# Service Information

Model Nakamichi 500  
Serial No. Up to 370140

Subject MHX Motor Ass'y and MHX Governor P.C.B. Ass'y No. NR-0006 (1/13)  
(B) Modification Procedures for Previous Models Date 9 August 1976

Fig.18 Auto Shut-off Ass'y

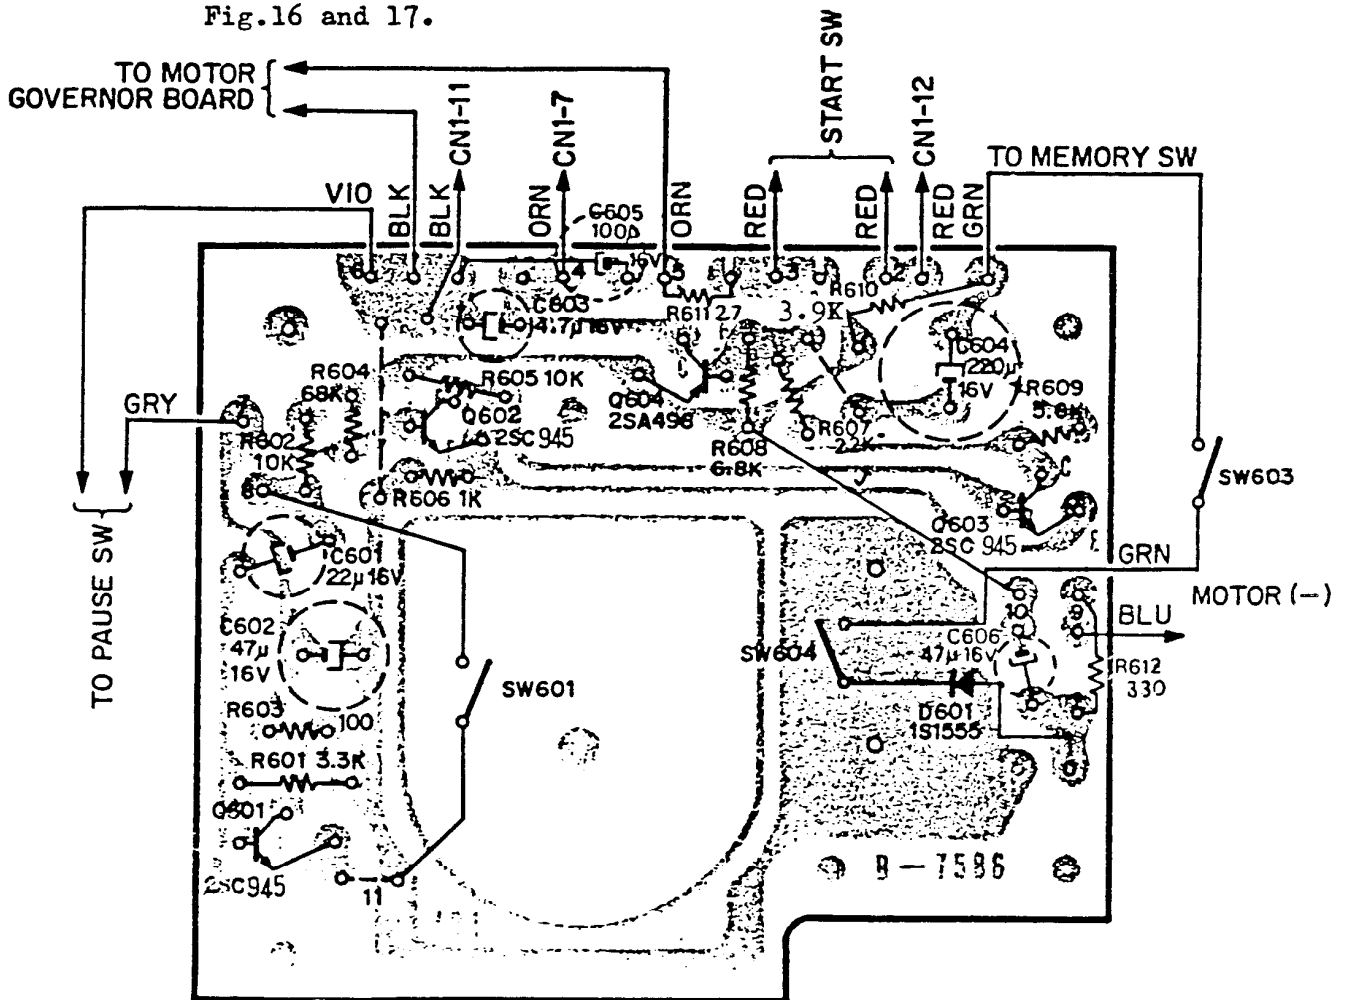
- (1) Unsolder signal wires from previous shut-off ass'y, and resolder to the new one (wiring arrangement is the same). Refer to Fig.18.
- (2) Remove earth-lug from the auto shut-off ass'y then insert the mylar washer between auto shut-off ass'y and chassis as illustrated in Fig.16.
- (3) Assemble the lug terminal and ceramic capacitors, referring to Fig.16 and 17.

Fig.19

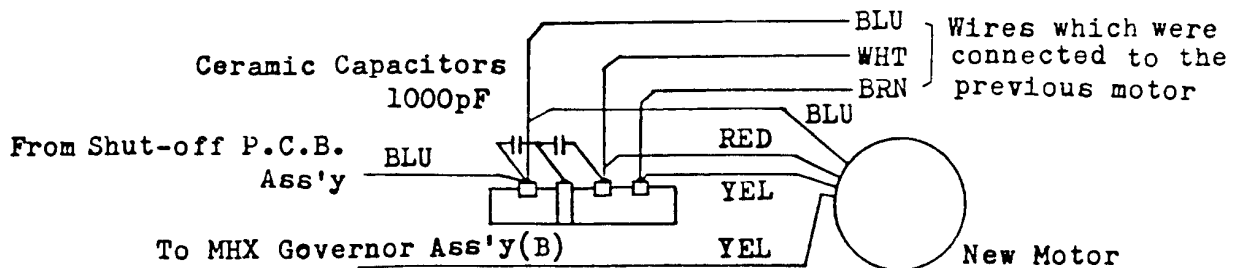
Connect the motor signal wires referring to Fig.16, 17 and 19.

Fig.20

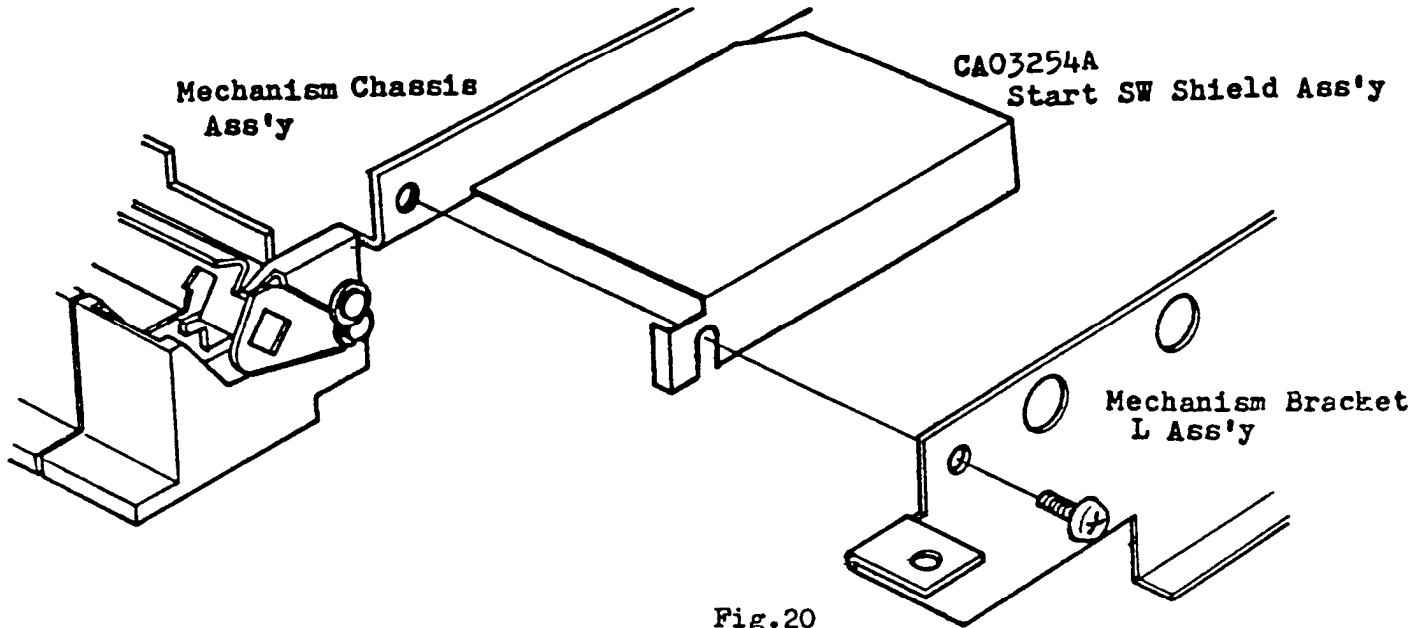
See Fig. 20. Loosen mechanism bracket L ass'y and insert the start sw. shield ass'y between mechanism chassis and mechanism bracket.
